Chemung County Stormwater
Construction Inspection
Erosion and Sediment Control

Project Name <u>Red Robin</u>	Date <u>6/16/2014</u>
Location <u>So. Tier Crossing</u>	Permit # <u>NYR10J873</u>
Weather Conditions <u>sunny</u>	Entry Time: <u>9:00</u>
On-Site Representative Present: <u>Raymond Miles</u>	Exit Time: <u>9:20</u>

PROJECT:	Red Robin
	Town of Horseheads
	Municipal Inspection
	June 16, 2014

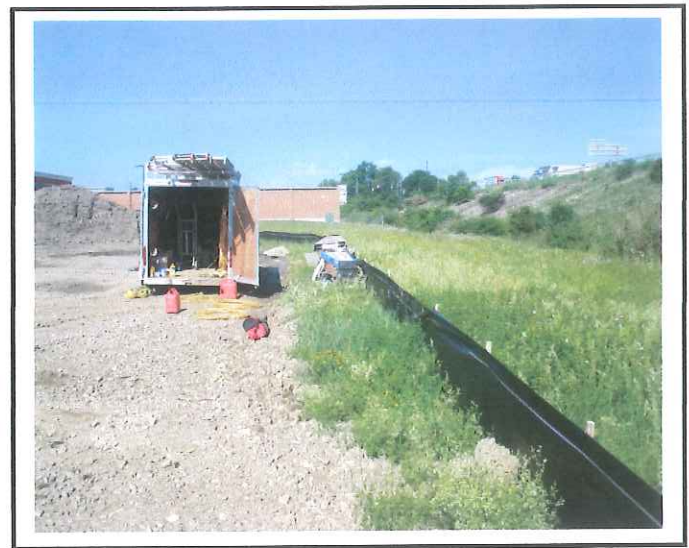
Construction entrance was recently re-topped with fresh stone.

Drop inlet protection has holes and needs to be replaced.

Concrete washout is near capacity and needs maintenance soon.

Silt fence maintained between project and stormwater swale.
